Service Bulletin #SB015

**Subject:** 3.5 CAR 2<sup>nd</sup> Post Modification

**Models Affected:** New, Listed 3.5 CAR cylinder/strap headramps

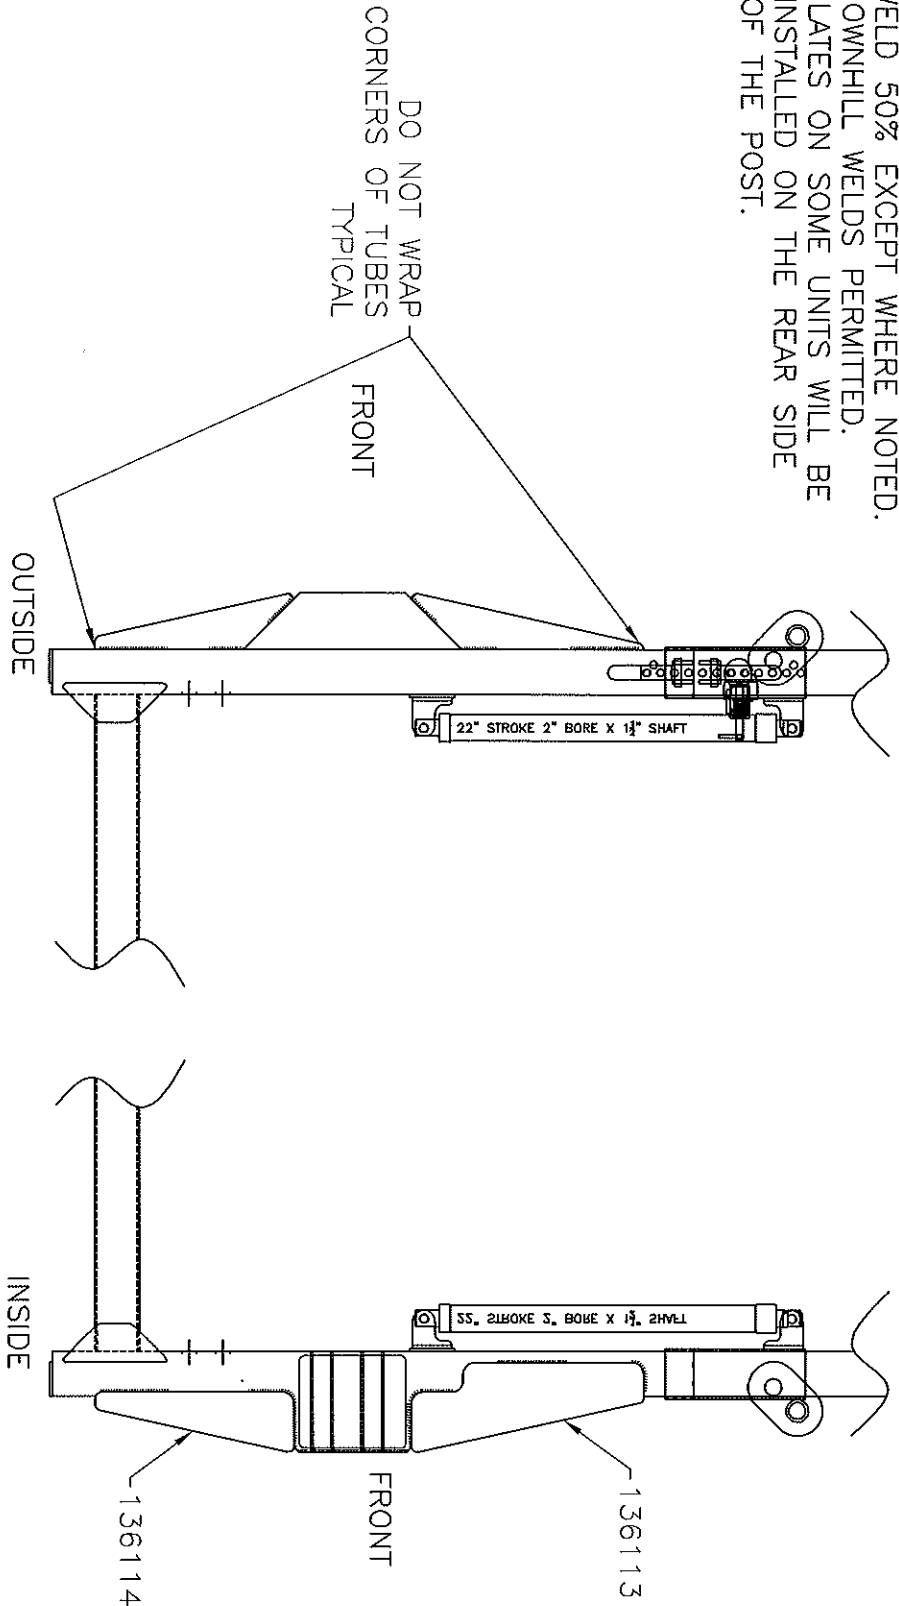
1. See enclosed drawing.
2. Remove hydraulic and electrical components from posts.
3. Gouge out and weld cracks.
4. Weld reinforcement plates as shown.
5. Replace hydraulic and electrical components in posts.
6. Touch up reworked areas.

- NOTES:
1. GOUGE OUT AND WELD UP CRACKS.
  2. WELD PARTS AS SHOWN.
  3. WELD 50% EXCEPT WHERE NOTED.
  4. DOWNHILL WELDS PERMITTED.
  5. PLATES ON SOME UNITS WILL BE INSTALLED ON THE REAR SIDE OF THE POST.

DO NOT WRAP  
CORNERS OF TUBES  
TYPICAL
